Comment Set E.18: Applicant – Visual Resources

Global Comments on the Visual Resources Analysis of the Antelope-Pardee Transmission Line EIR/EIS

Thomas Priestley, Ph.D. AICP/ASLA
CH2M HILL

Response to Comment Set E.18: Applicant – VISUAL RESOURCES

FIGURE 3
SCE ANTELOPE-PARDEE 500 kV
TRANSMISSION PROJECT
REVIEW OF EIR/EIS

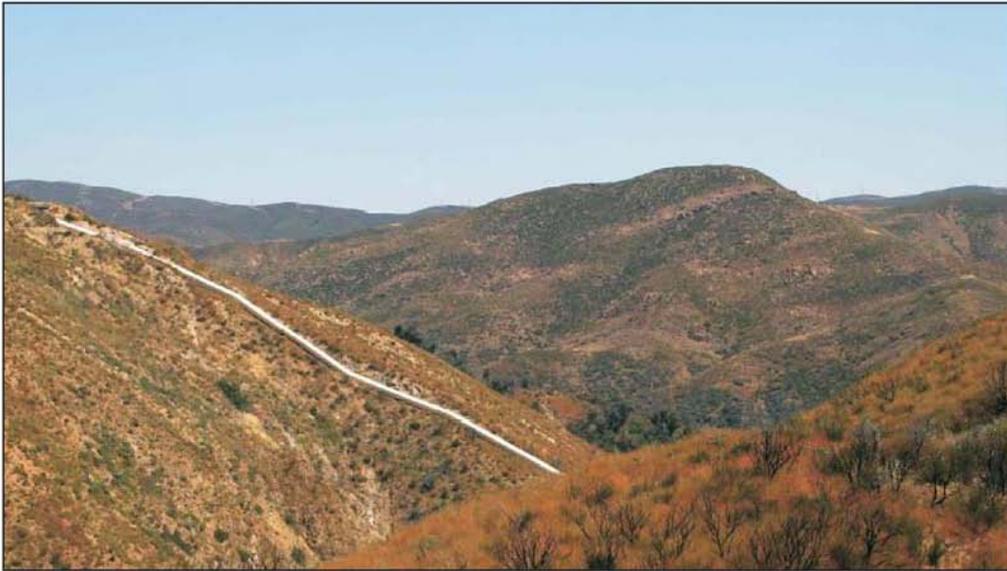
3a: Signage on the fence at the entrance to the LADWP service road across the Bouquet Reservoir dam communicates that public use of the reservoir and the area around it is not permitted.

3b: View of Bouquet Reservoir from Bouquet Canyon Road in the area east of the dam. In all views toward the reservoir from Bouquet Canyon Road, the reservoir is seen through the chain link security fence that dominates the foreground of the view.

- E.18-30 This photograph shows a close-up view of the signage at the turnout, but contrary to the assertion that this sign would prohibit public use and enjoyment of the turnout, which it does not, the sign communicates “no trespassing, parking, dumping.” Common sense dictates that this reservoir can be enjoyed for its scenic attributes without climbing over the fence and entering the water. Stopping at the turnout to enjoy the view, or to analyze the proposed Project, is not prohibited; only trespassing, parking, dumping is prohibited.

- E.18-31 The caption for this photograph contends that the chain link fence dominates the view. That contention is left to the decision makers to decide. It can be argued that the chain link fence is transparent if attention is drawn to the middleground and background mountains.

FIGURE 4
SCE ANTELOPE-PARDEE 500 kV
TRANSMISSION PROJECT
REVIEW OF EIR/EIS

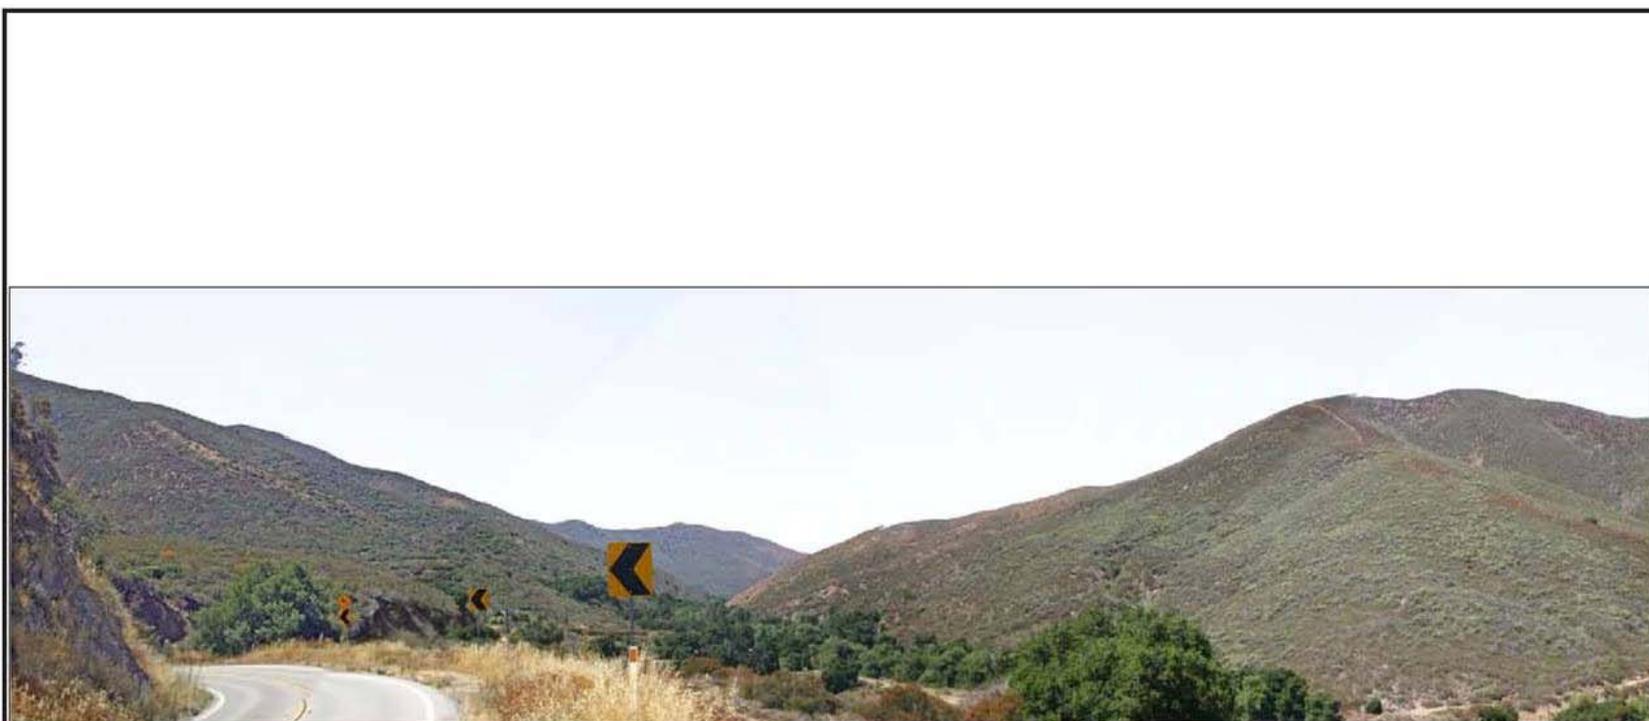
4a: This is the view that the EIS/EIR uses for KOP 5, which is intended to represent views toward the project route from San Francisquito Road. This view is taken from one of the few points along the road where there are no transmission towers in the foreground.

4b: View looking southwest from San Francisquito Road toward the project route on the distant ridgeline from a point to the immediate west of EIR/EIS KOP 5. (photo 4a above) This view is more typical of views from San Francisquito Road than the KOP 5 view because it includes several of the existing transmission lines that dominate the foreground of the views from the road corridor.

- E.18-32 The photograph at E.18-32 does not meet “the accepted professional standards for creating photographic images that are equivalent of what is seen by the human eye.” This photograph is an excellent example of the distortion that occurs when 1) a wide-angle lens is used, 2) a photograph is reduced in size to fit onto an 8 ½ x 11 page, and 3) a photograph is cropped to fit into an area with dimensions wider than tall and different than the 3x2 proportions of a 35mm camera. However, no substantiation is given to the parameters of the photograph at E.18-32, which leads to a false assertion about the visual effects Alternative 2. In fact, the EIR/EIS describes this view, without representing it in a photograph or a simulation, and predicts that the visual effects would be significant, as quoted above in E.18-25. Also, please see response to Comment E.18-3, above.

- E.18-33 The photograph at E.18-33 shows Existing Visual Conditions as seen from KOP 5, and asserts that “This view is taken from one of the few points along the road where there are no transmission towers in the foreground.” This assertion is not based in fact, and is not supported by any maps or additional photographs, and therefore, can be dismissed. In fact, based on numerous site visits and study of aerial photographs and topographic maps, it can be said that there are many locations along San Francisquito Canyon Road where there are NO transmission towers in the foreground.

FIGURE 5
SCE ANTELOPE-PARDEE 500 kV
TRANSMISSION PROJECT
REVIEW OF EIR/EIS

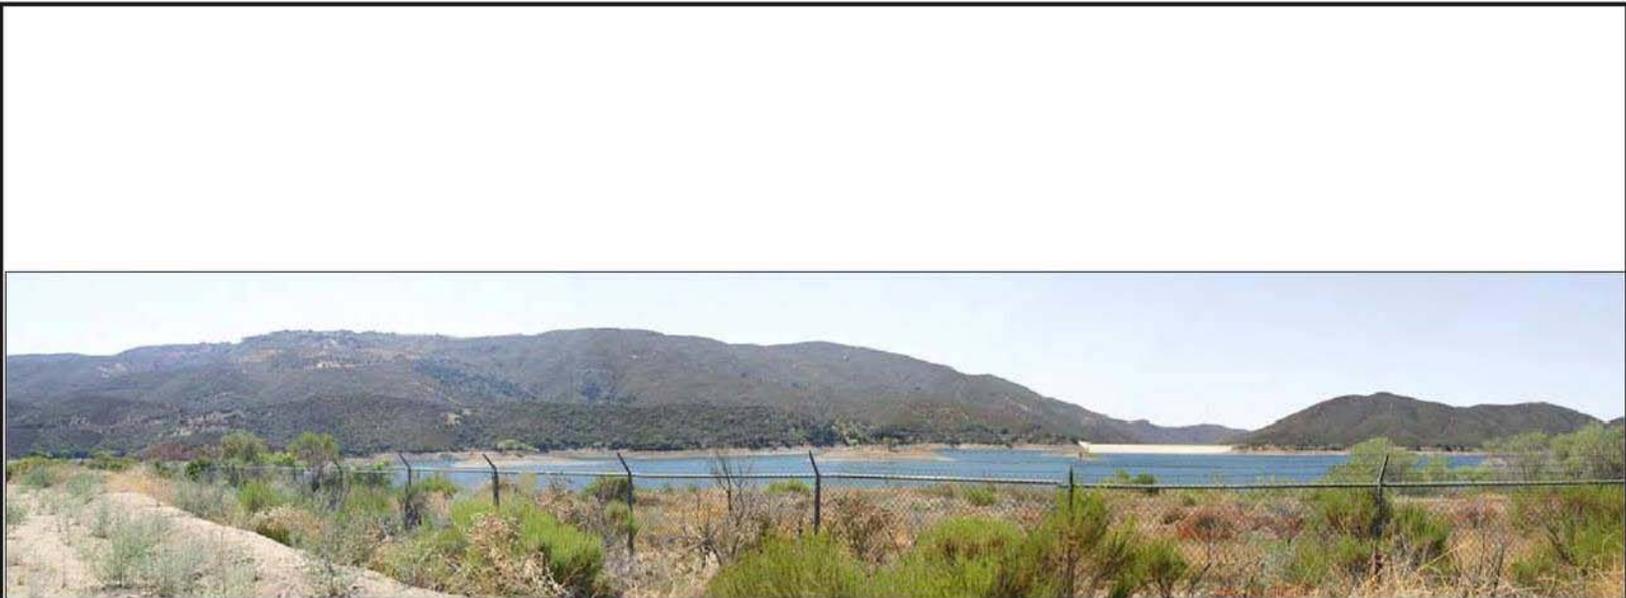
Westbound view from Bouquet Canyon Road just west of the Bouquet Reservoir dam. Alternative 2 (the "Midslope Alternative") would cross over the valley in the middle of this view, and would entail placement of a tower on the top of the peak on the right side of the the view.

- E.18-34 The photograph at E.18-34 is an accurate representation of the existing foreground view and Unacceptably Low Scenic Integrity Level that exists on NFS lands along San Francisquito Canyon Road. As stated in the response to Comment E.18-14 above, the presence of multiple infrastructures (500-kV, 1000-kV transmission lines and a pipeline) in the foreground of San Francisquito Canyon Road do not justify the introduction of a new 500-kV transmission line on Del Sur Ridge in the middleground view from KOP 5. The proliferation of large transmission lines would create additional visual impacts, and this is well represented in the photograph at E.18-34, where existing visual conditions clearly do not meet the Forest Service HIGH SIO.
